UNITED STATES PATENT AND TRADEMARK OFFICE

APPLICATION NO.	FILING DATE	FIRST NAMED INVENTOR	ATTORNEY DOCKET NO.	CONFIRMATION NO.
10/501,237	07/12/2004	Stephane Phelep	0510-1100	5317

Office Action Summary

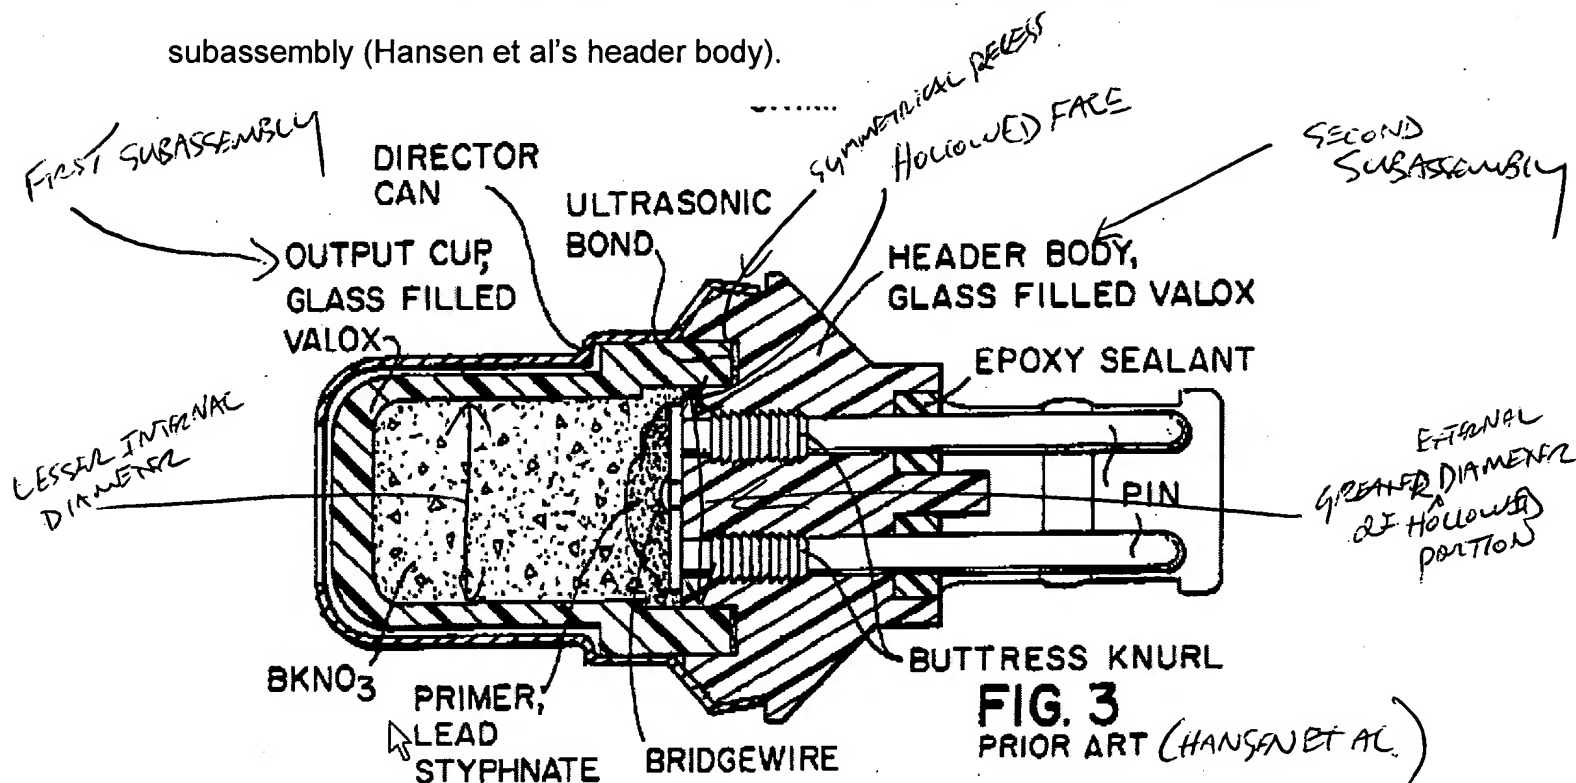
Regarding claims 2 and 11, see the marked up copy of Hansen et al's Fig. 3.

Regarding claim 9 and 10, Hansen et al's pins comprise electrodes that are scored (buttress knurl - fig. 3 above).
